MUNICIPAL REVISE PERMIT AND INSPECTION RECORD 03/17/2025
MUNICIPAL NO.2024-045077 FOLIO: 3220220090010
JOB SITE ADDRESS 7900 NW 154 ST
PROPOSED USE OFFICE - PROFESSIONAL BUILDINGS
LEGAL MIAMI LAKES BUSINESS PARK SEC 1 PB 126-54
APPLICATION TYPE ALTER INTERIOR 23000 SQFT 0 UNITS 0 FLOORS
OWNER NAME HUNDREDFOLD HOLDING 7900 LLC
CONTRACTOR CAMCON GROUP LLC
QUALIFIER
PERMIT TYPE MUNICIPAL BLDG
CATEGORIES 0001 MUNICIPAL GENERAL BUILDING

WARD LAW GROUP
7900 Miami Lakes Dr, Ground Floor
Miami Lakes, FL 33016

Please find below a written narrative of Revision 10 to the Ward Law Group, Ground Floor Renovation. Revisions were due to comments received Miami Dade Fire Department and Electrical. Please let us know if there are any questions, comments, or concerns.

Ward Law Group-Response to Comments-Rev 10 RWK 2025-03-07.pdf

1/2" = 1'-0"

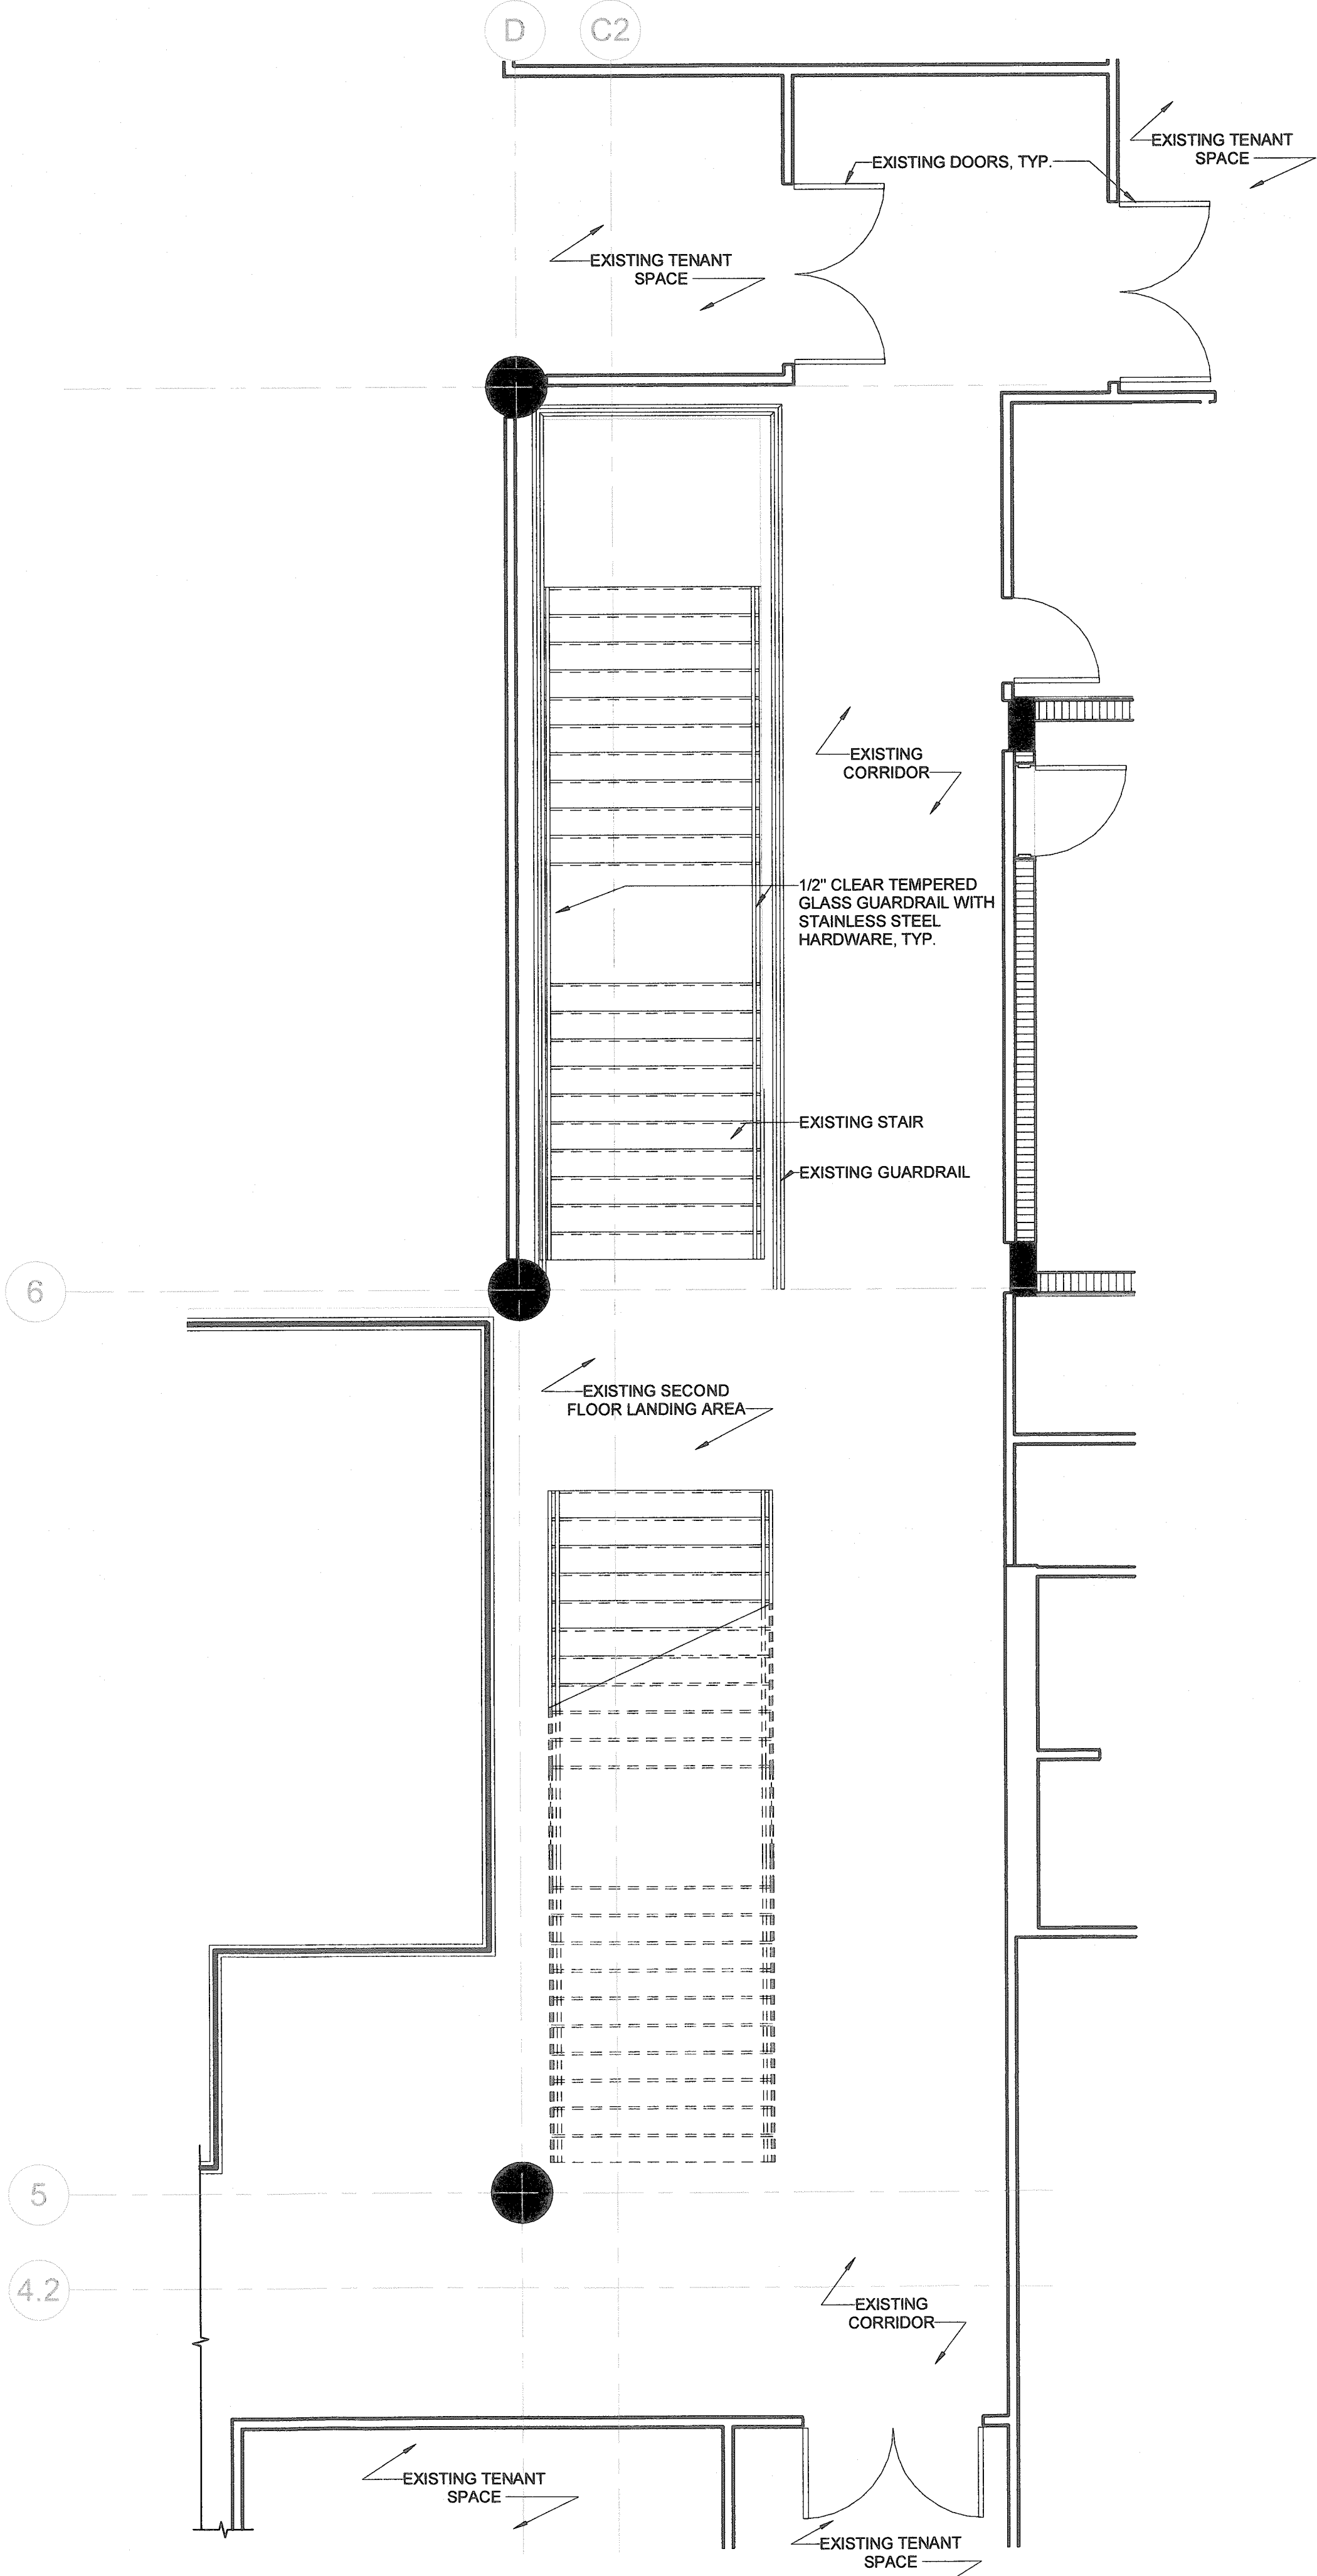
MDFR NOTE: EXISTING UNPROTECTED VERTICAL OPENING NOT IN COMPLIANCE WITH FFPC 101.38.3.1 TO BE CORRECTED UNDER SEPARATE PLANS PER AGREEMENT WITH AOR. 04/30/2024 MEETING.

LIFE SAFETY PLAN

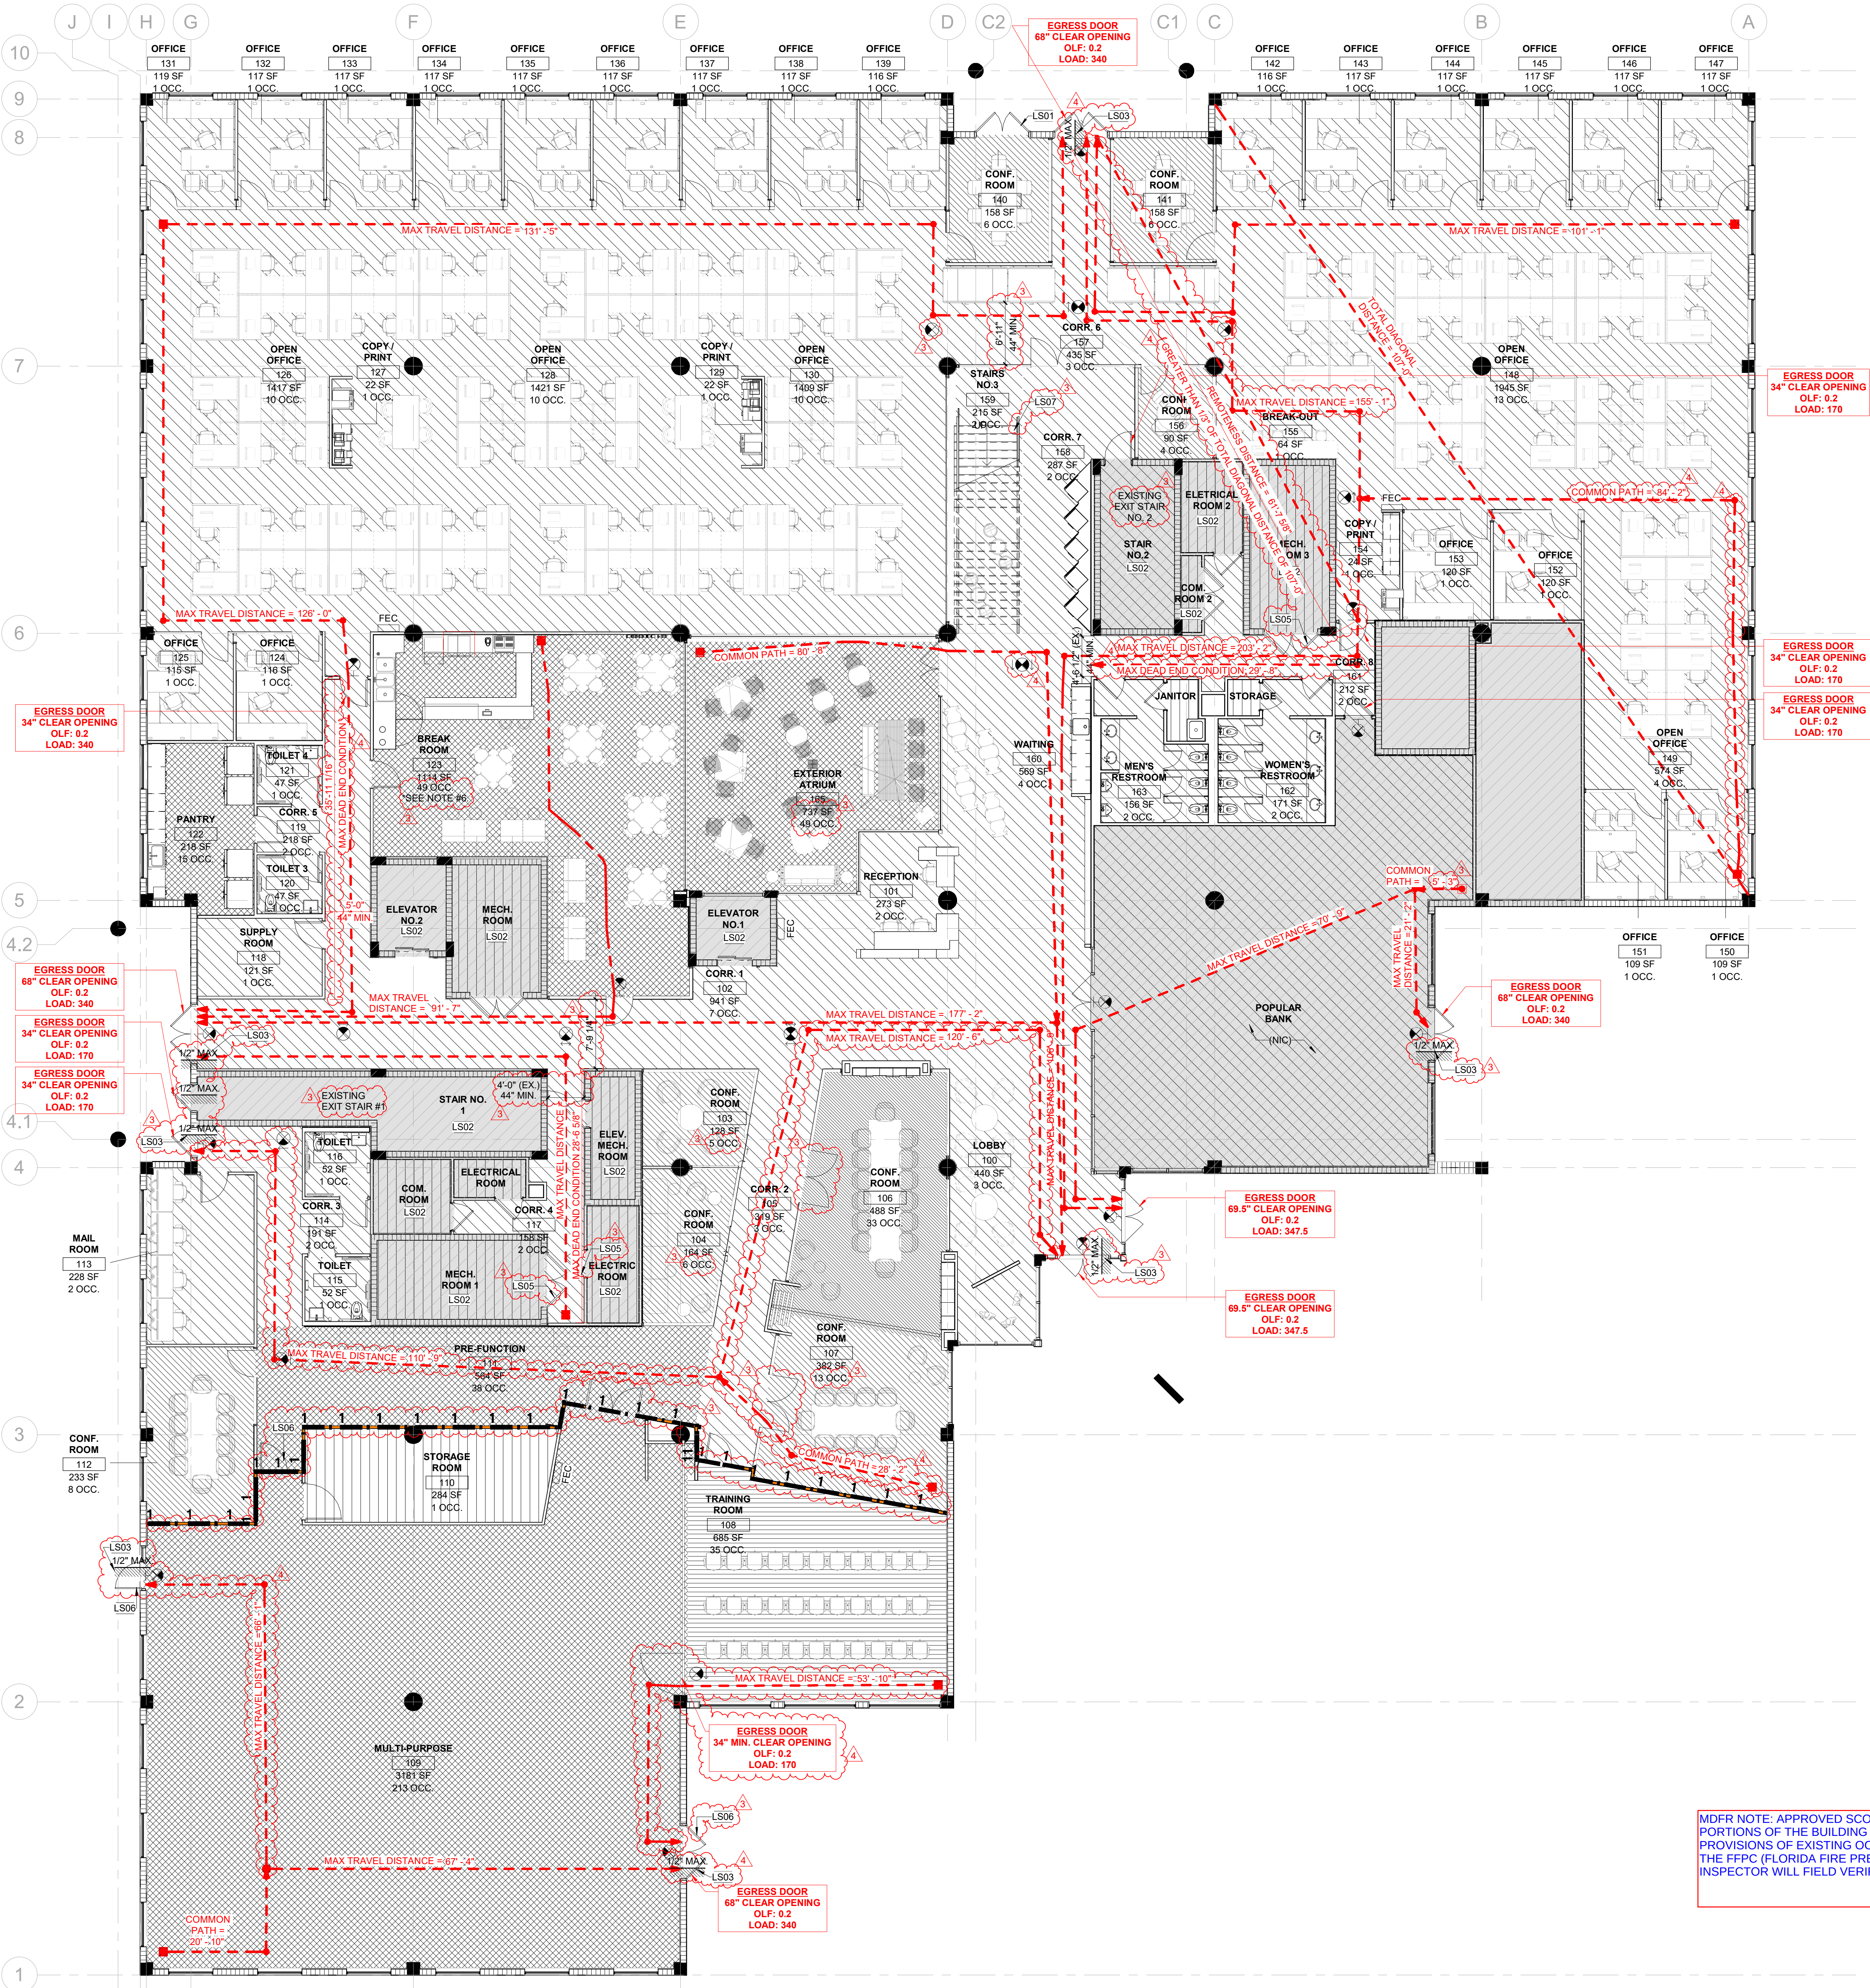
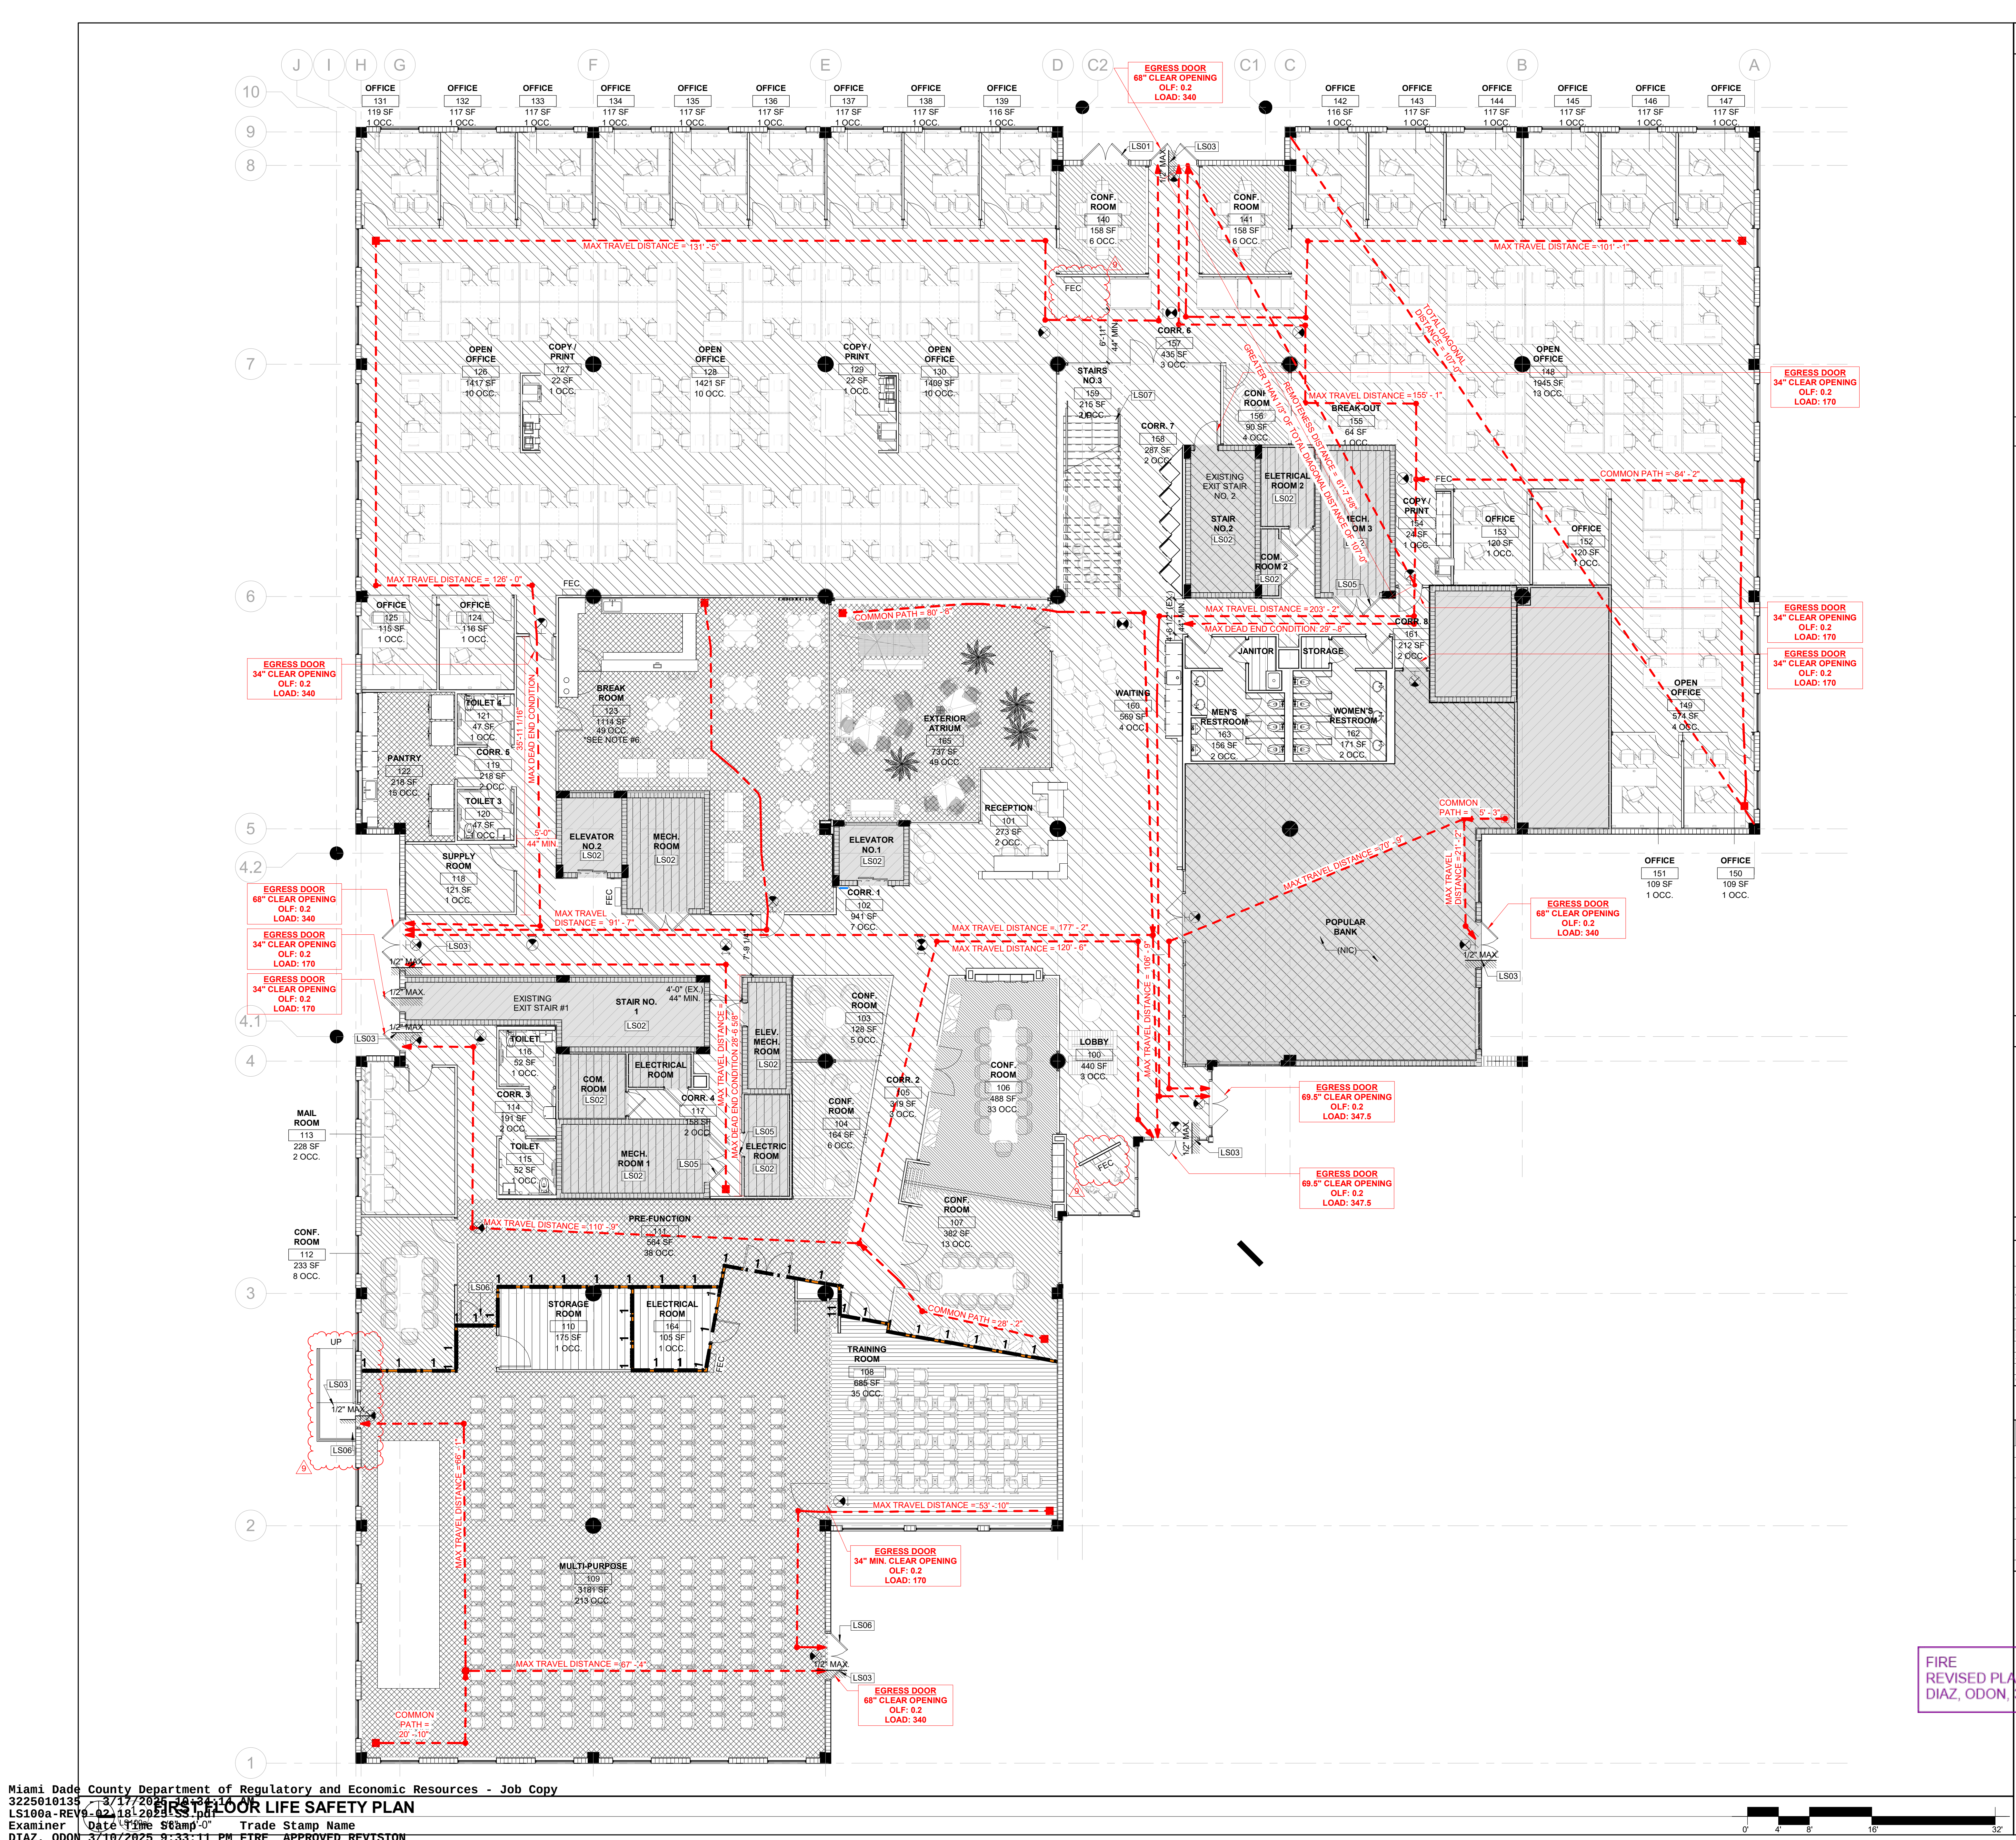
MDFR NOTE: APPROVED SCOPE OF WORK ONLY, EXISTING PORTIONS OF THE BUILDING SHALL COMPLY WITH THE PROVISIONS OF EXISTING OCCUPANCIES, AS SET FORTH IN THE FFPC (FLORIDA FIRE PREVENTION CODE). FIRE INSPECTOR WILL FIELD VERIFY
